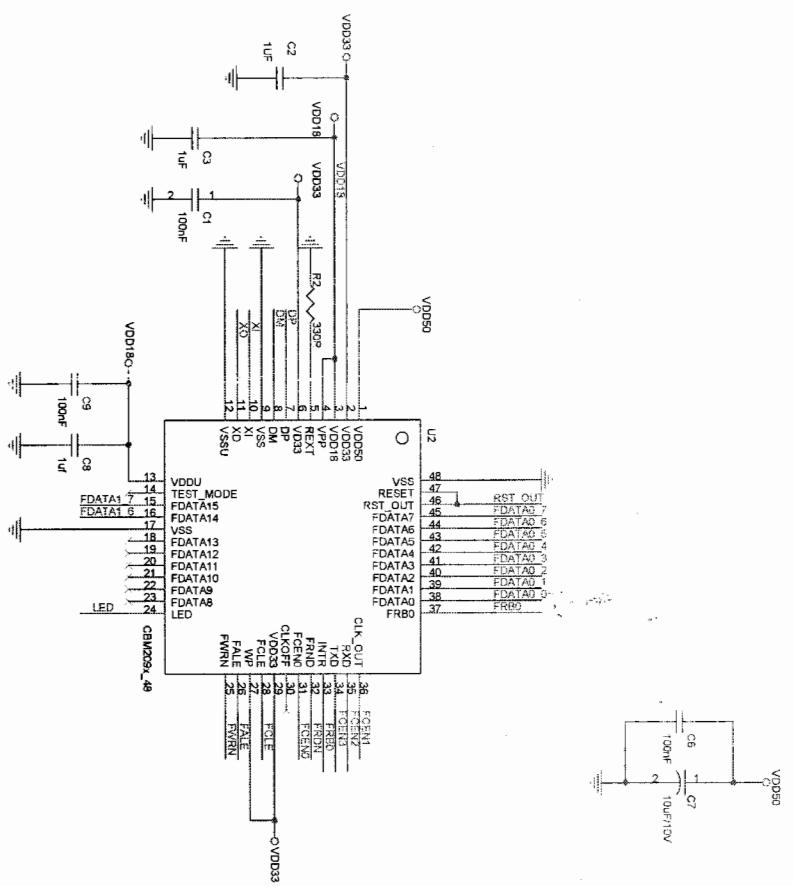
C8,C9 need Approaches the 13 Pin

NOTE 3:  
If don't consider ESD, The R11  
should be removed, otherwise all of  
them should be added.
